TECHNICAL SERVICE BULLETIN

Subject:
KE30 to KE30H

Reference: TSB# 060112

Date: June 25 2012

KE30 vs KE30H

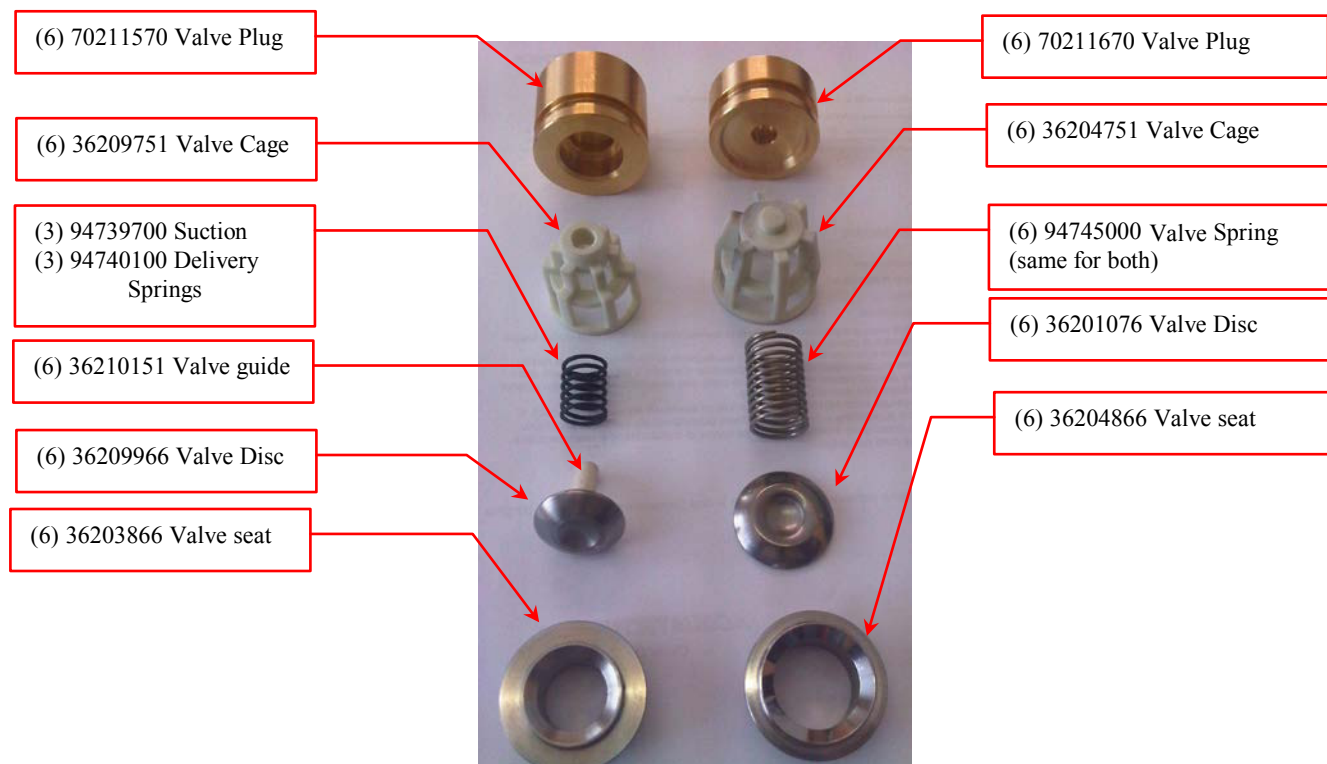
This Technical Bulletin describes the recent changes to the KE (70 series) pumps. This is intended to improve the volumetric efficiency of the large flow rate versions of the 70 series pumps. Models affected by this change are KE28, KE30. With this change comes a new part number; these models are now known as KE28H, KE30H and a new model KE36H. The main feature of this change is the larger internal passages, allowing better fluid flow into, and out of the plunger chamber.

In order to convert or up date from one check valve type to the other the brass valve plug will also need to be changed. There is a total of 6 of the same valve plug used in one pump. The part number for the new one is illustrated above **(70211670)**. These assemblies are interchangeable with between the KE30 and the KE30H.
